**VISUAL SITE INSPECTION REPORT - 2017**

SOUTHERN INDIANA GAS AND ELECTRIC  
A. B. BROWN GENERATING STATION  
TYPE III RESTRICTED WASTE LANDFILL  
WEST FRANKLIN, IN

ATC PROJECT NO. 170LF00430

DECEMBER 18, 2017

Project Number: 170LF00430	Dwn. By: CR	Drawing File: SEE LEFT	Ckd. By: CD	App'd By: 	Ckd. Date:
<b>2017 INSPECTION SITE PLAN</b> TYPE III RESTRICTED WASTE LANDFILL A.B. BROWN GENERATING STATION					
Date: 12/17					
Scale: AS SHOWN					
Figure: 1

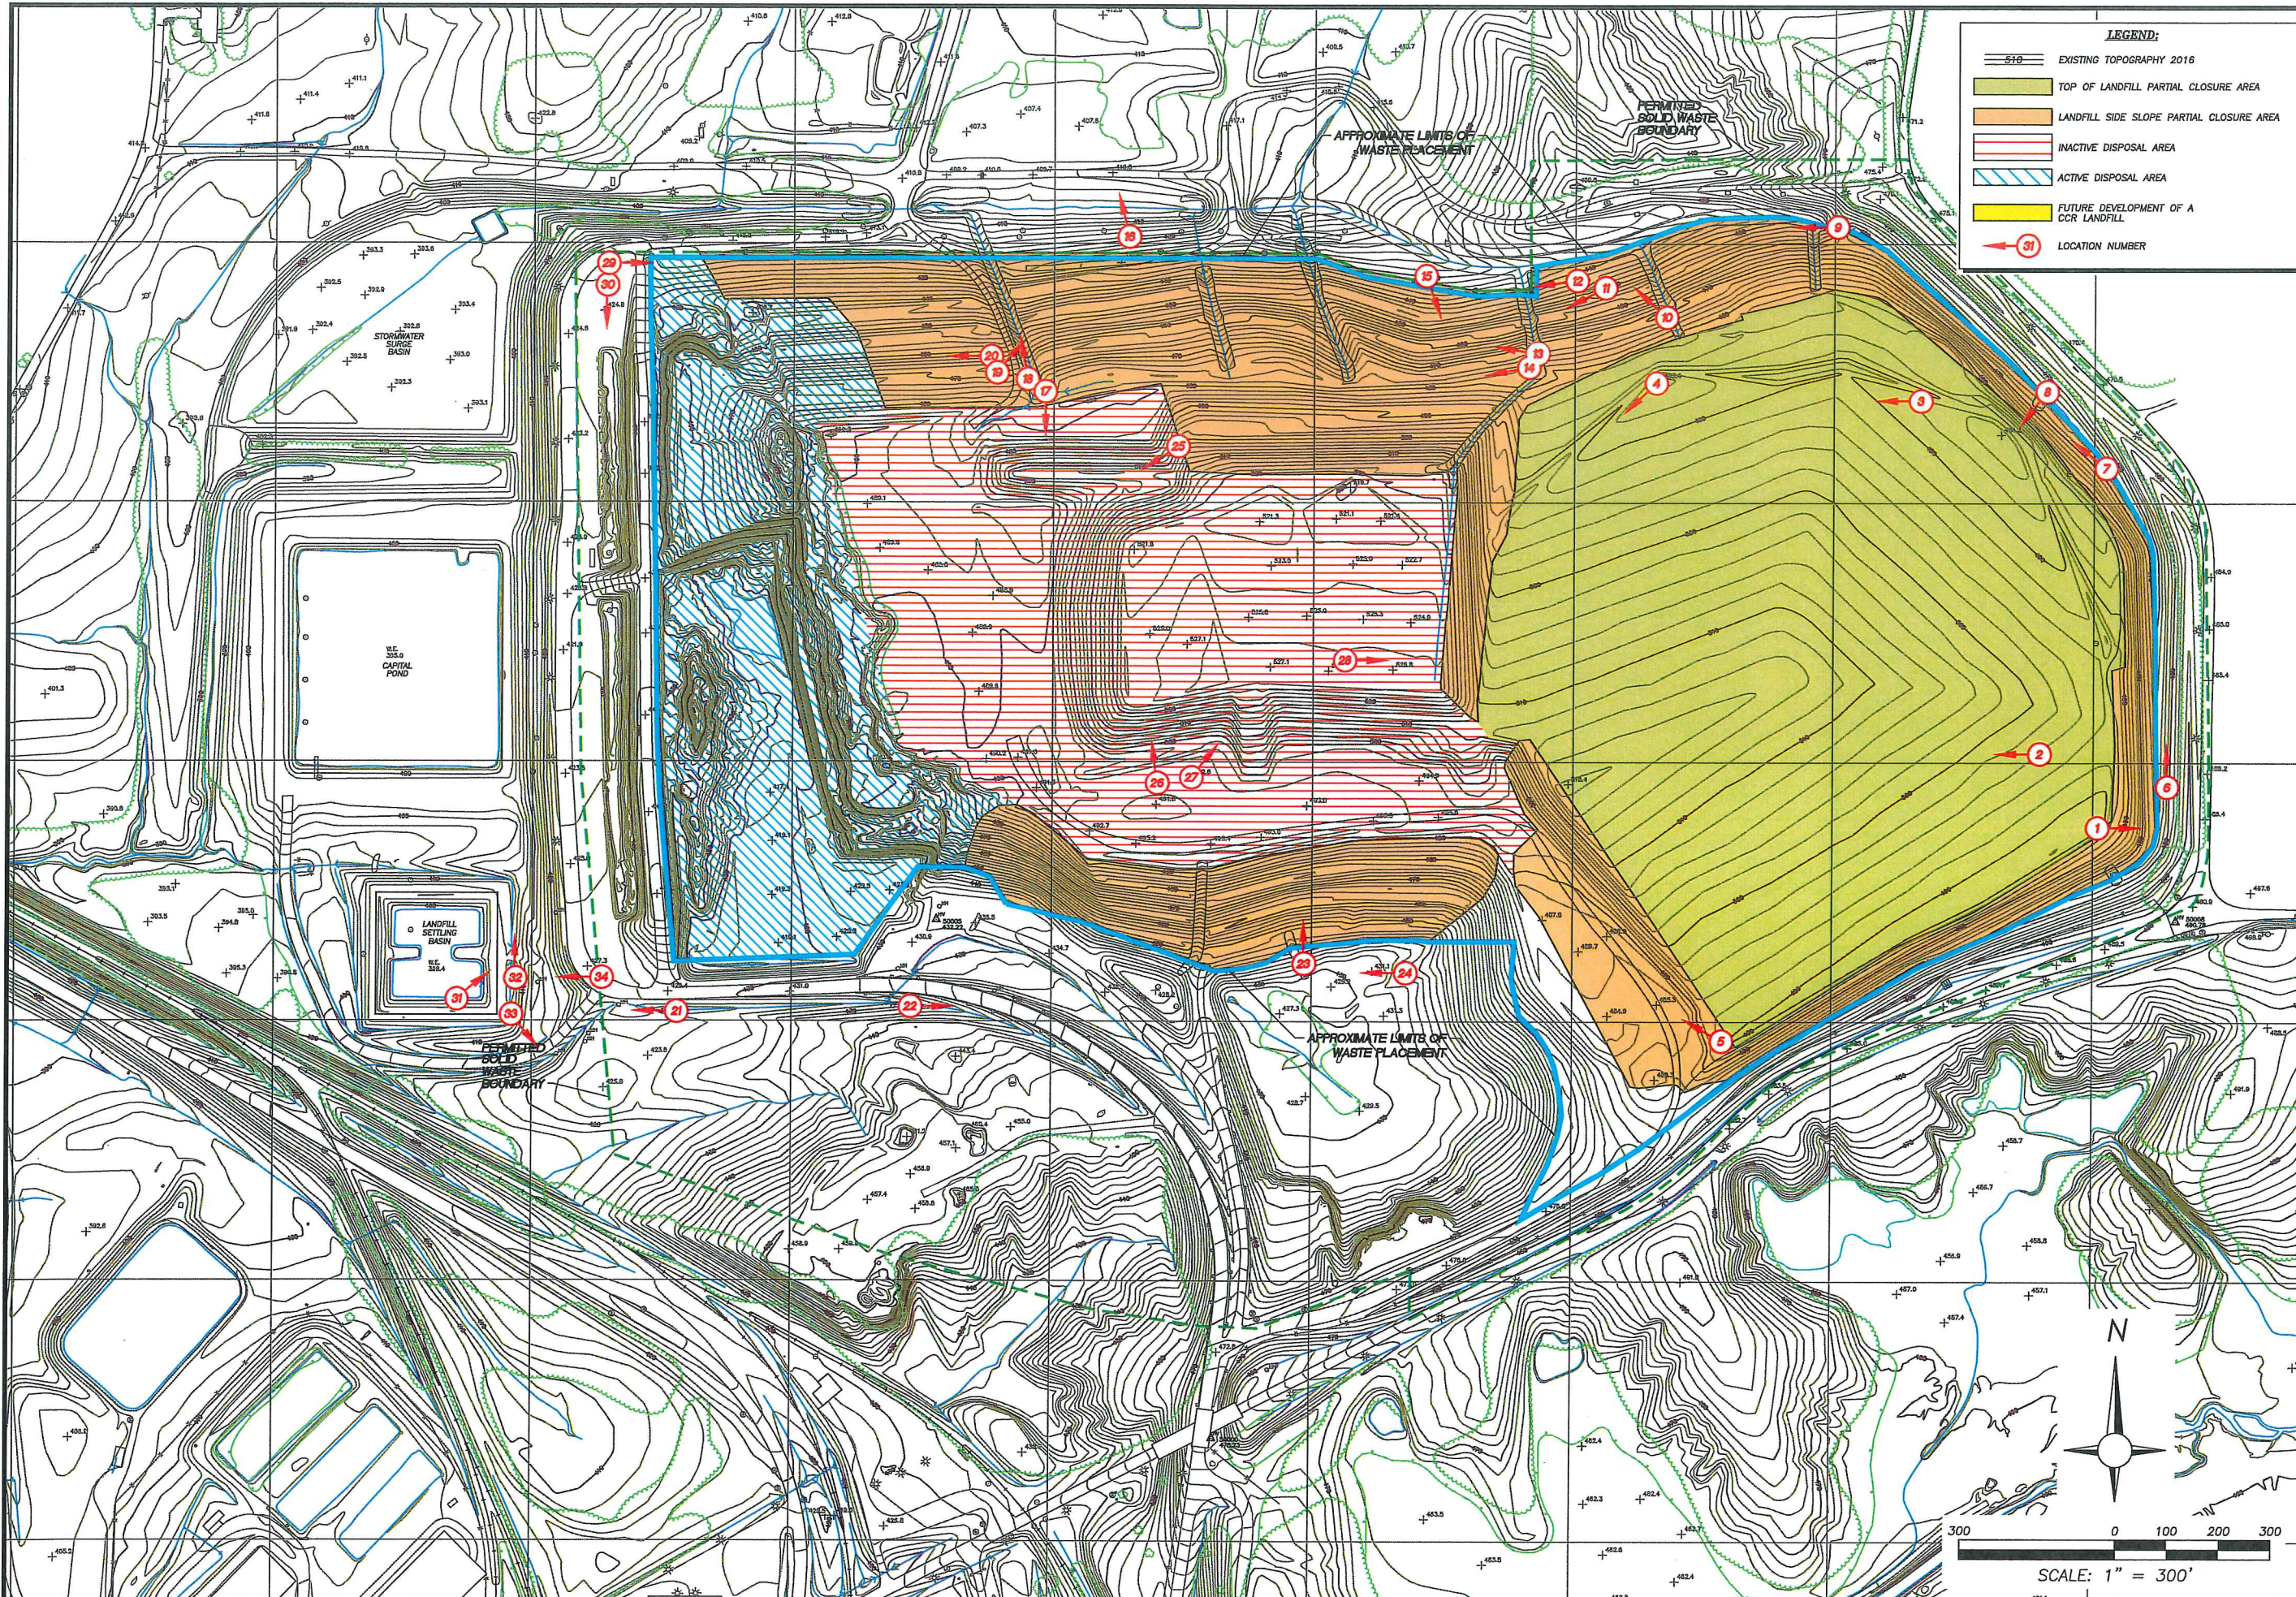
- 2) Several surface depressions/erosion features have formed in areas adjacent to riprap downchute channels, along the flow line of diversion berms and alongside downdrain pipes (Locations 8 and 10). One such erosion feature, adjacent to a riprap downchute channel, located on the north side of the landfill, west of the north-south haul road on the backside of the upper level berm (Location 19) is approximately 8-feet long, 2-feet wide, and 1-foot deep. An additional erosion feature is located alongside one outlet pipe drainage structure near the base of the landfill in the vicinity of the perimeter ditch on the east side of the landfill.

- 3) The perimeter ditch on the south and east sides of the east partial closure area is generally well vegetated. Some areas along the ditch do, however, have standing water where equipment has left shallow depressions from track marks. (Location 7).

- 4) The downdrain pipes and the riprap lined downchutes on the north side of the landfill are generally in good condition. The outlet area at the top of one of the riprap downchute channels has formed erosion gullies just downstream of the culvert inverts. (Location 17).

- 5) A seep is present on the north slope near the east end of the landfill. A trench has been excavated in the area to collect the seep water and convey it in pipes to the Capital Pond. It is our understanding that the flow rate varies seasonally and that the peak rate continues to decrease following the construction of the composite final cover across the top of the east end of the landfill. Early in the fall of 2016 a hay bale diversion berm was replaced upstream of the trench to divert potential overland runoff from intermingling with seep waters. It appears that a straw waddle has also been added to divert stormwater from the trench.

- 6) A toe drain pipe near Riser Pipe #5, located on the north edge of the landfill, adjacent to the perimeter ditch, has salt deposits on the exterior of the pipe and around its base (Location 15). Additionally, some salts were noted along the north side of Manhole #10. Neither area appeared to be blocked at the time of inspection however these salts indicate past blockage in the pipes. According to visual inspection, water levels appeared to be normal inside manholes, so blockage at the time of inspection is unlikely. The facility has recently installed additional manholes and lines to alleviate potential blockages that may be associated with the toe drain lines. Additionally, a controlled chemical flush and vac procedure was performed in the summer of 2017 to clear lines.

- 7) There are seeps discharging from the south slope that collect in the valley (bowl) area. This includes seeps noted within one of the riprap lined downchutes. The combined flow rate at the time of this visual inspection was estimated to be approximately 1 gpm. The toe of slope is generally wet and covered with phragmites with isolated areas of standing water (Location 23).

- 9) There are salt deposits in the perimeter ditch located south of the landfill and the inlet to the culvert of the drainage ditch is nearly totally blocked with sediment (Locations 21 and 22). At the time of the inspection these salt deposits were discussed with facility personnel and were determined to be the likely result of runoff from the haul road.

- 10) The south slope of the landfill immediately north of the "bowl" area had not been mowed at the time of inspection which made it difficult to thoroughly inspect this area (Location 24). Per facility personnel, shortly after the time of inspection, this area was mowed.

- 2) The area along the south-facing slope of the vertical expansion portion of the landfill is a relatively flat terrace which transitions to a section of the partial closure slopes described in the previous section (Location 26). It appears that the area was regraded in 2017 to try to minimize the potential for the ponding of surface water. Per facility personnel, a pipe inlet was installed to collect from the lowest spot and direct water to a down drain pipe in the bowl.  
**Recommendation: Monitor this area during wet season conditions. If surface water ponds in this area, additional modifications should be made to the grades in this area to promote surface water runoff.**

- 2) At the northwest corner of Cell 18 at the edge of the haul road, the water surface of the standing water in the cell is only slightly below road elevation indicating a small amount of freeboard (Location 29). During large magnitude storm events the cell may become more susceptible to overtopping.

- 1.) The upstream slopes of the sediment pond were lined with riprap and appeared in satisfactory condition (Locations 31 & 34). However, soil erosion has occurred on the east bank of the pond above the inlet pipe.

- 3.) As noted in the landfill sideslope partial closure area, salt deposits were noted in the ditch along the east and north banks of the pond near the manhole upstream from the sediment basin inlet pipe (Location 32) and also downstream of the green culvert pipe located at the southeast corner of the Sedimentation Basin (Location 33). It appears that the salt deposits are associated with surface water runoff from the landfill haul road.

**Recommendation: Fill depressions and erosion gullies. Either revegetate or apply additional riprap as needed. Where needed, divert water around the erosion area to prevent continued erosion. Monitor the repaired areas for the redevelopment of the erosion.**

**Recommendation: Fill depressions along the ditch to prevent standing water accumulation in the ditch.**

**Recommendation: Fill and line the outlet area with gravel or erosion control mat to prevent erosion at the outlets.**

**Recommendation: Continue to collect and convey the seep water by discharging to the Capital Pond.**

**Recommendation: Continue a regular maintenance program on the toe drain lines to minimize the potential for development of blockages.**

**Recommendation: Continue to collect water discharging from the seeps and route to the Capitol Pond through the Sedimentation Basin. Monitor the area between the south side of the Vertical Expansion Area and the north slope of the bowl area to prevent the ponding of surface water which could be a source of water for the seeps. .**

**Recommendation: Continue to implement good engineering controls for haul trucks to prevent spilling of CCR material onto perimeter roadways and ditches. Evaluate options to redirect haul road runoff to direct water back to the truck pit or other methods of routing water to the lined sediment basin.**

**Recommendation: The slope should be mowed on a regular basis to facilitate inspection of this area.**

**Recommendation: Maintain a low normal pool elevation inside the cell collection area and continue to monitor elevation rise during storm events. Consider additional drainage from inside the cell or the addition of a soil berm to increase freeboard in this area as needed.**

**Recommendation: Place erosion control or stormwater diversion above the riprap slope to prevent soil erosion into the pond. Overseed recent areas of disturbance along the east overbank below the haul road.**

**Recommendation: Modify the drainage ditch located on the south side of the haul road to discharge to the lined sediment basin.**
